**Jacob's Landing
Stream Restoration Monitoring Report
DMS Project # 95024
DMS Contract # 003984
Monitoring Year 05**

Subject: Jacob's Landing Stream Restoration Site
MY-05 Monitoring Report Comments
Yadkin River Basin CU 03040105
Rowan County, North Carolina
NCDMS Project # 95024
Contract # 003984

Please find below our responses in italics to the MY-05 Monitoring Report comments from NCDMS received on January 22, 2019, for the Jacob's Landing Stream Restoration Site.

DATE: JAN 2019
 SCALE: GRAPHIC
 CURRENT CONDITION
 PLAN VIEW
 SHEET 1 OF 2

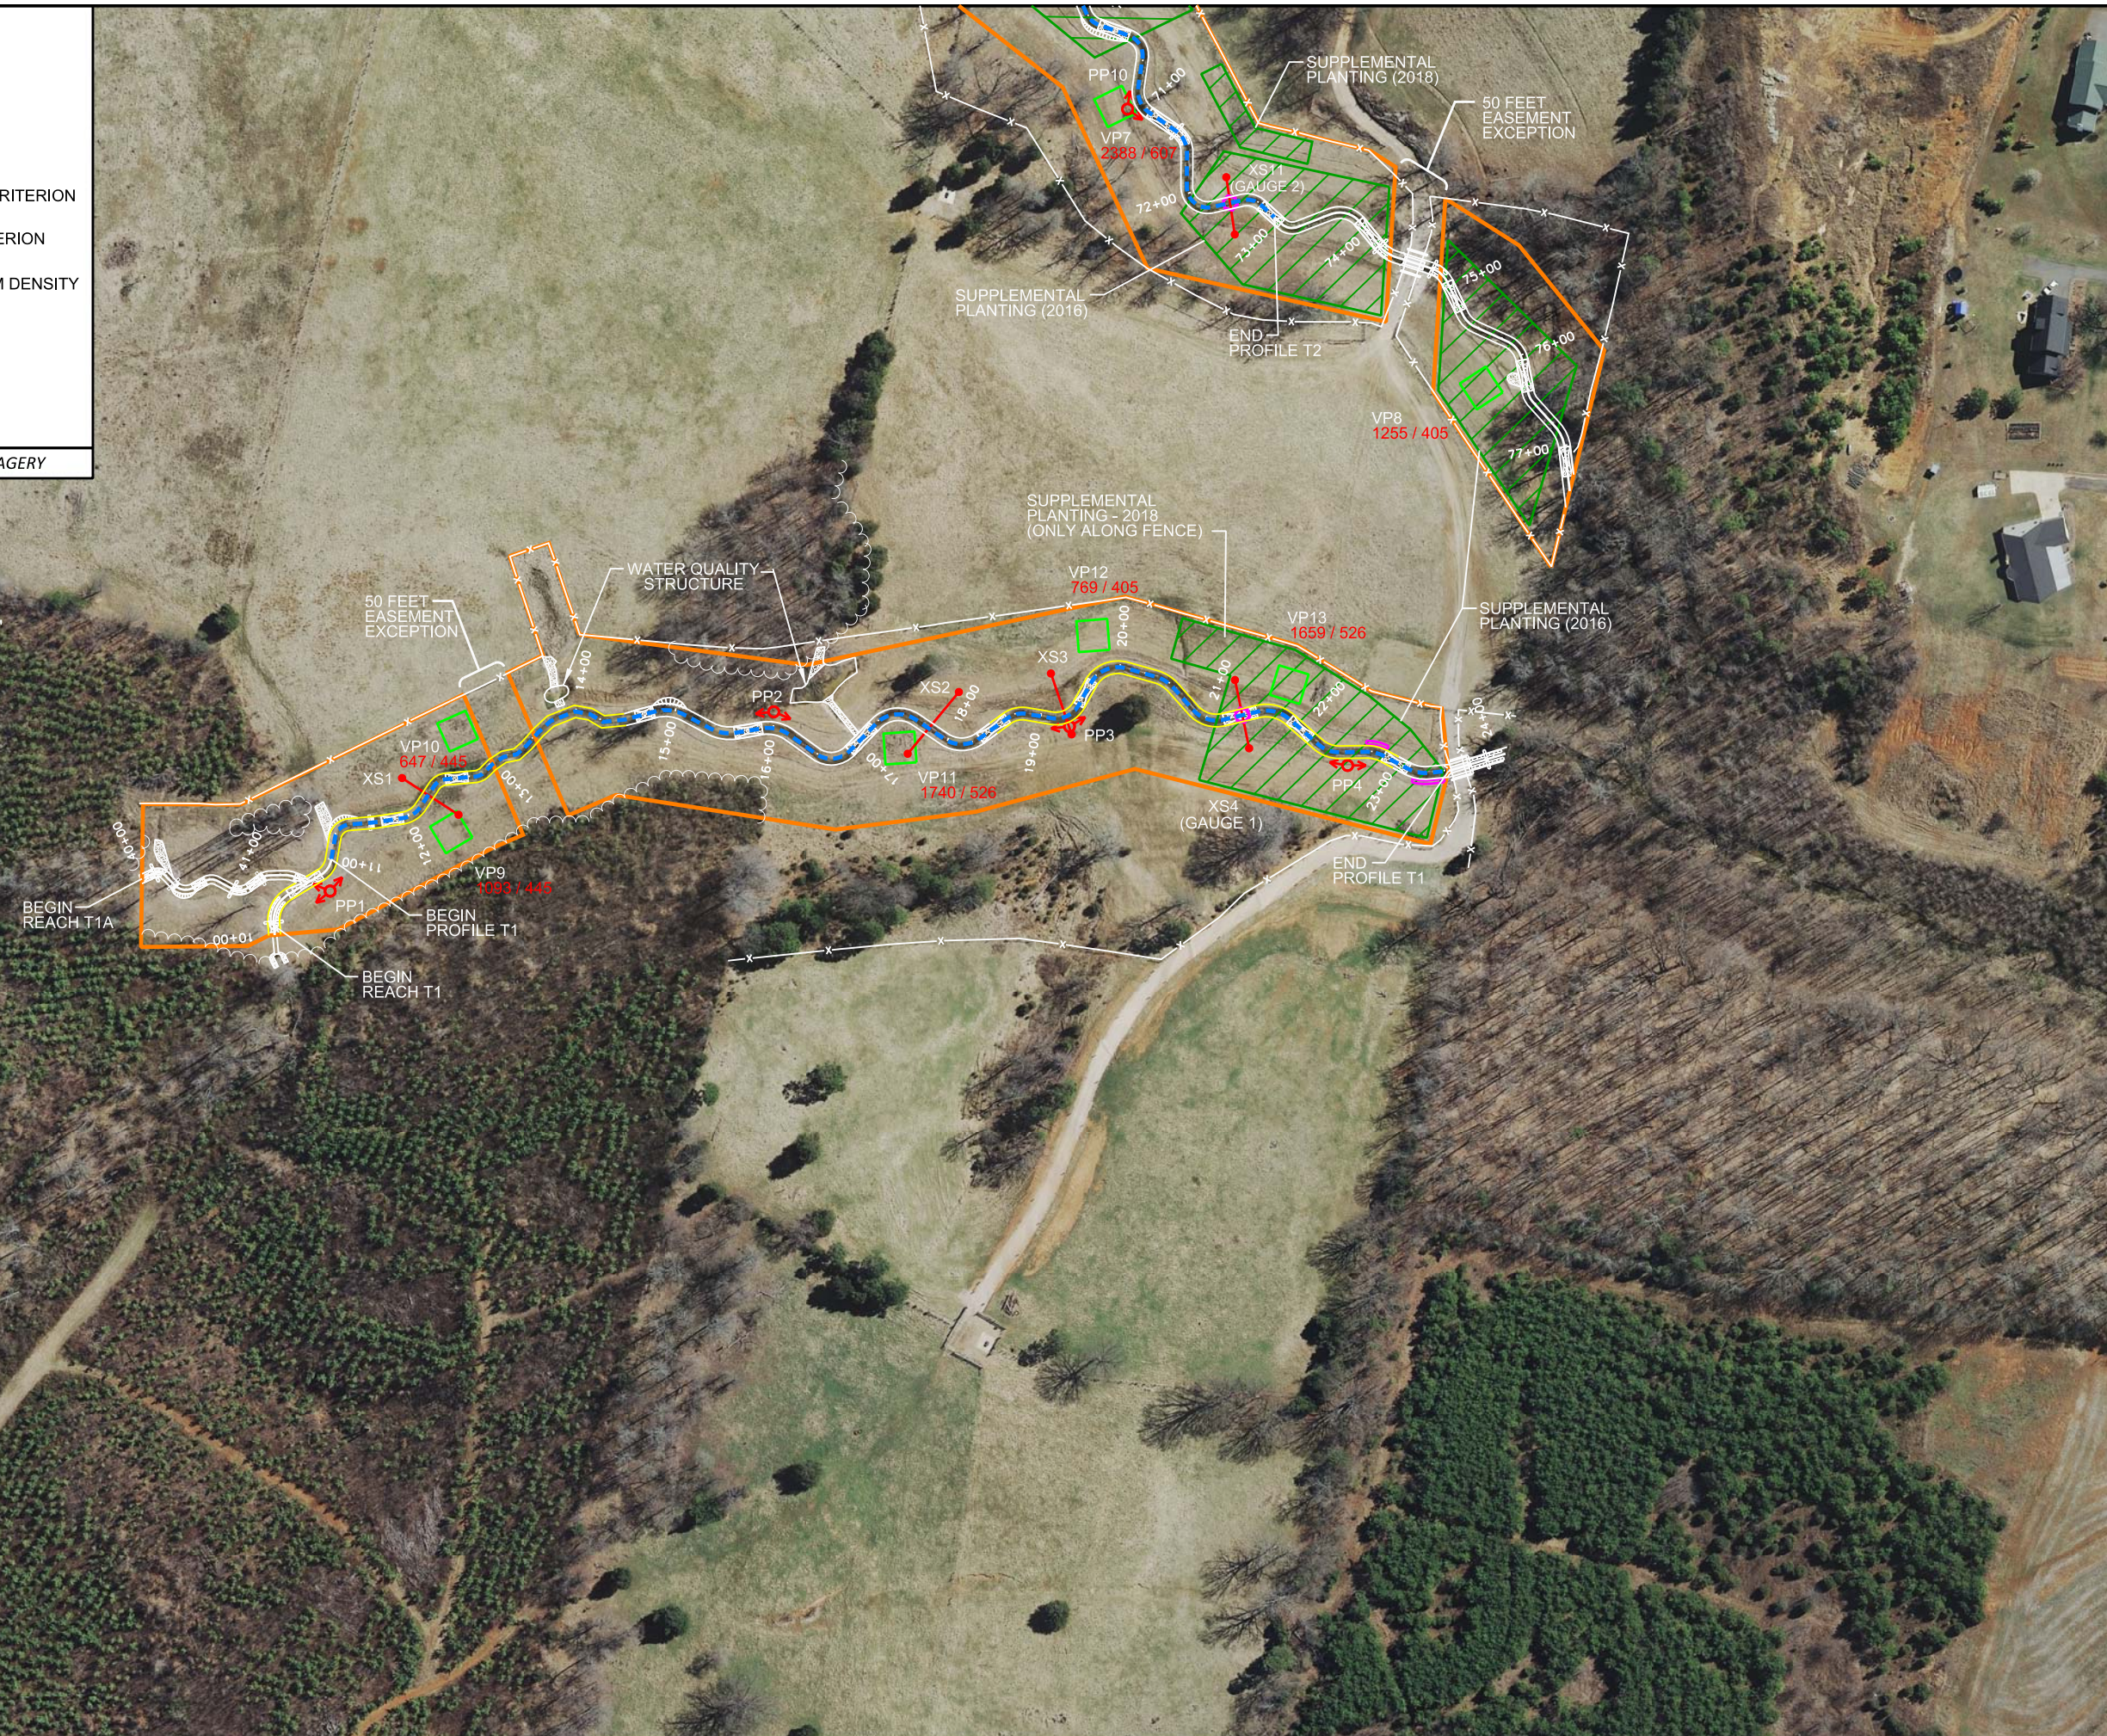
- Report discusses supplemental plantings that occurred in 2015 and 2018. CCPV shows supplemental plantings dated 2016 and 2018. Please revise and/or update report discussion to include all supplemental plantings. A short discussion regarding size, quantity and species would be helpful. Did the planting that occurred in 2018 affect the outcome of the vegetation plot totals? Is the 2016 planting referring to the 2015 effort, or was this a separate supplemental planting?

- *The reference to a 2015 planting was a typo. The only supplemental plantings that occurred on site were in 2016 and 2018. This error has been corrected and a brief description of the extent of each planting has been added to the report. No new stems were reported in any of the veg plots in 2018.*

DATE: JAN 2019
SCALE: GRAPHIC
CURRENT CONDITION
PLAN VIEW
SHEET 2 OF 2

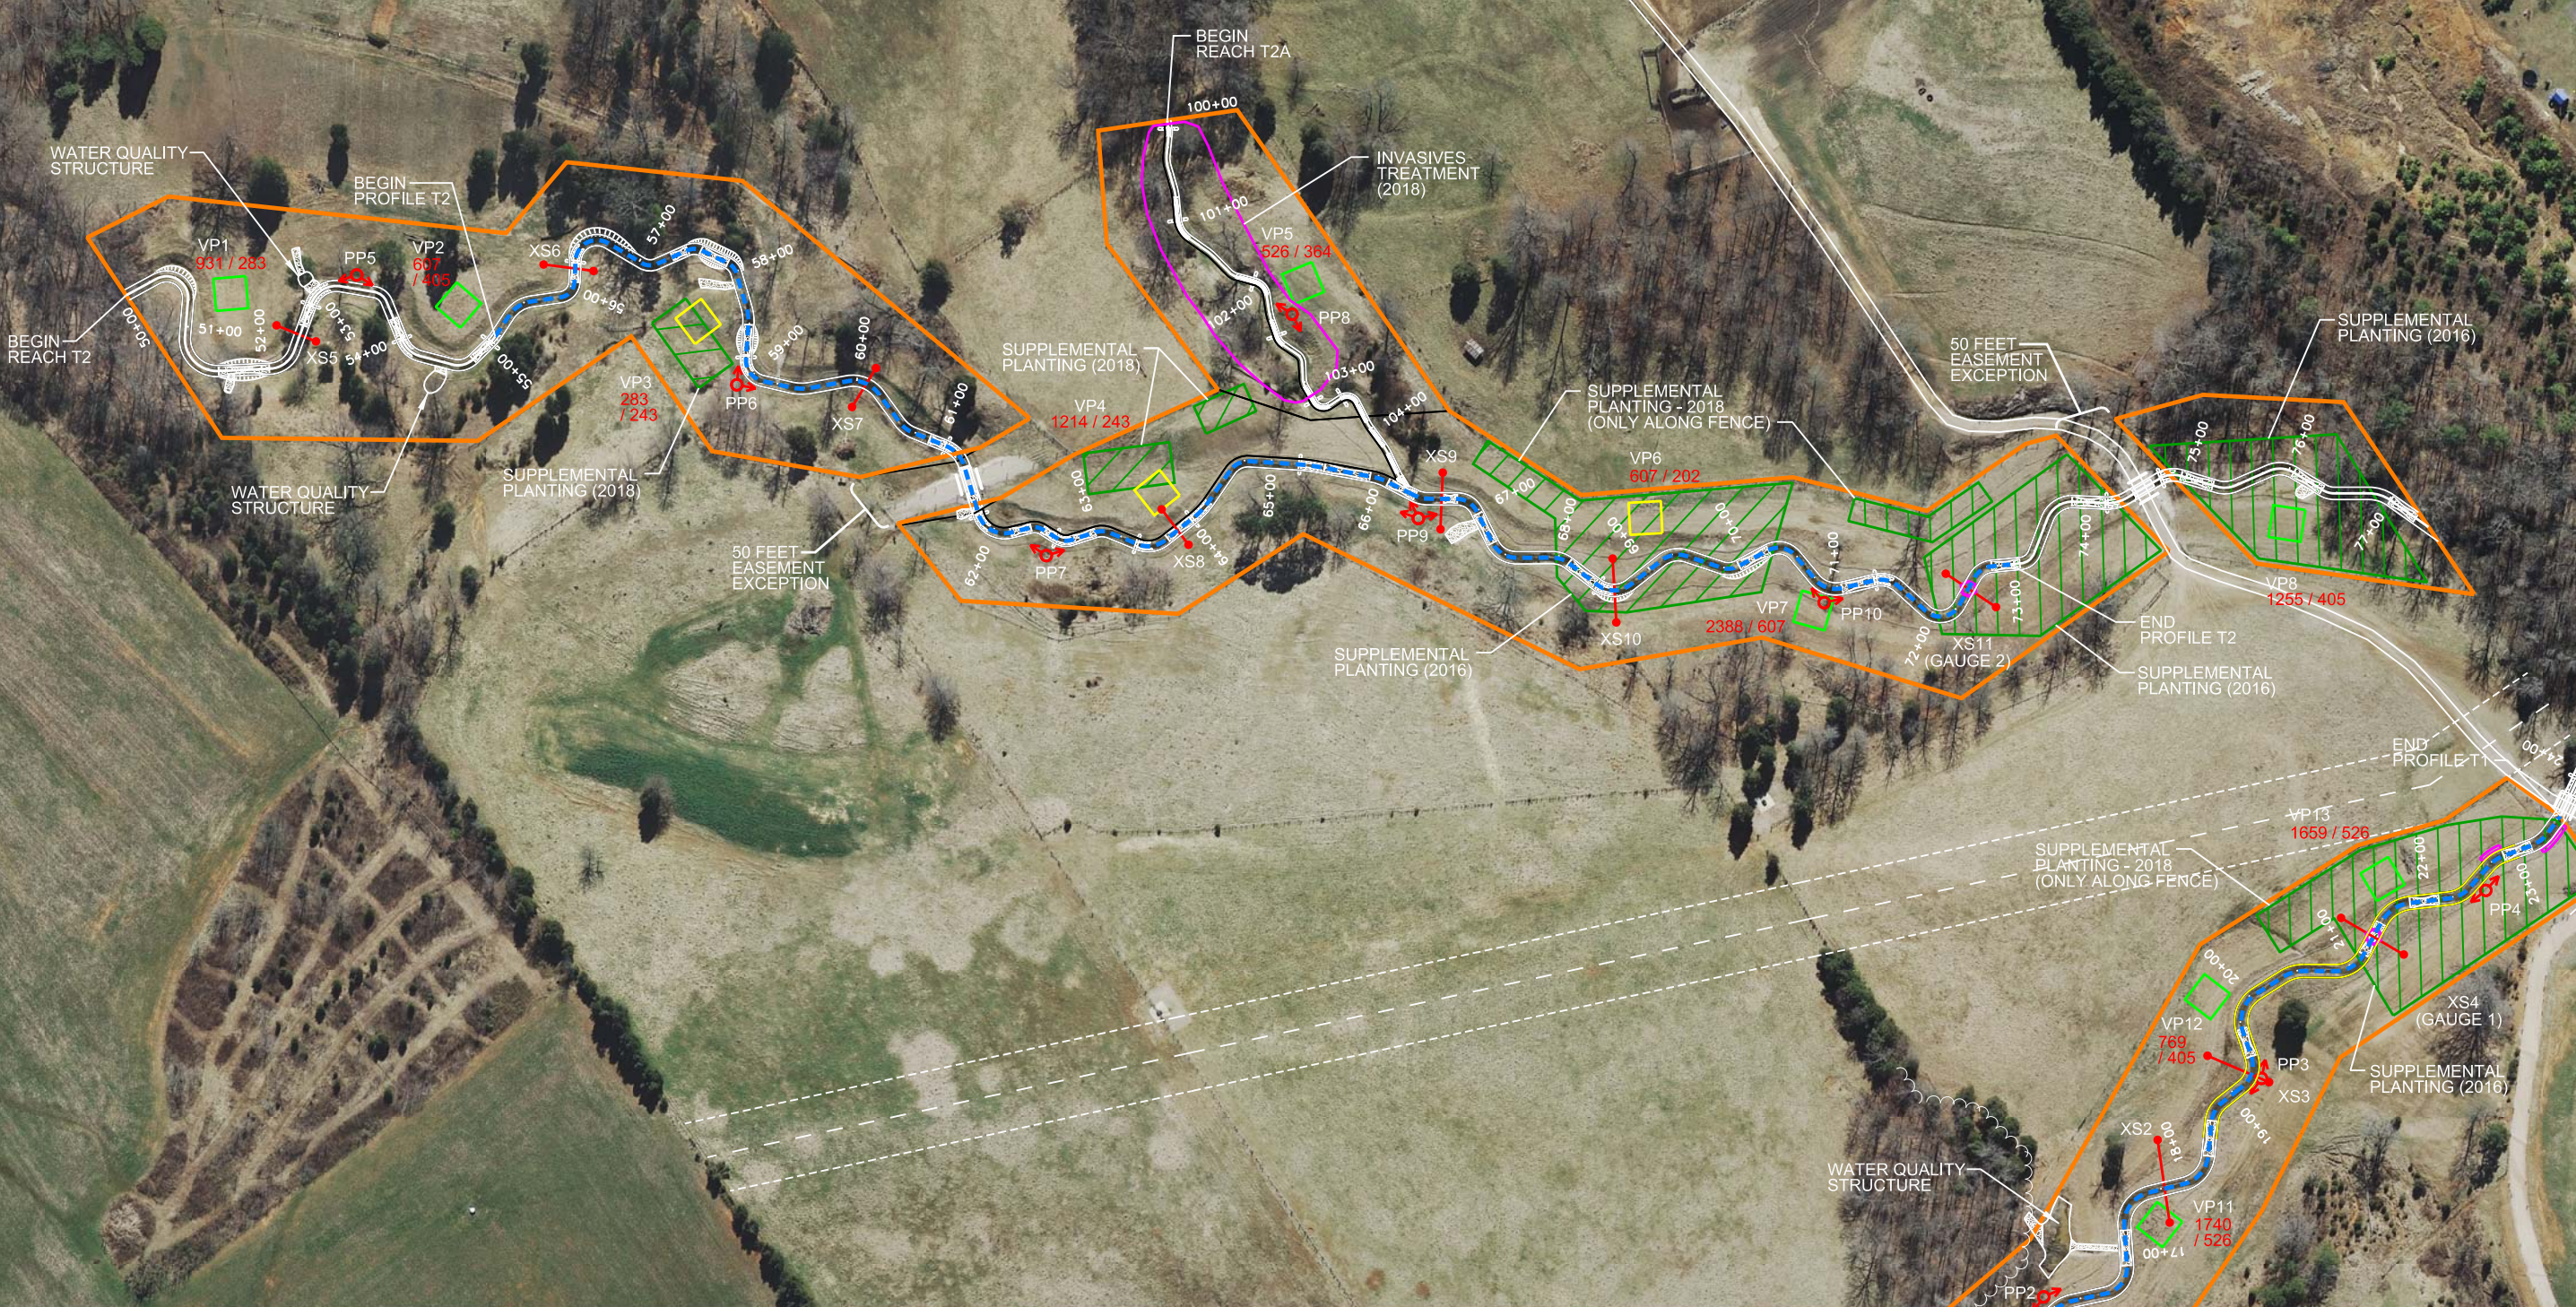
- DMS met with KCI on December 4, 2018 to view the Jacob Landing site. Dense privet was observed on Reach T2A. Please show this area on the CCPV and include the treatment date if it has occurred on Table 2.
 - *This area of privet was treated on December 13, 2018. This date has been added to Table 2 and the area has been added to the CCPV.*
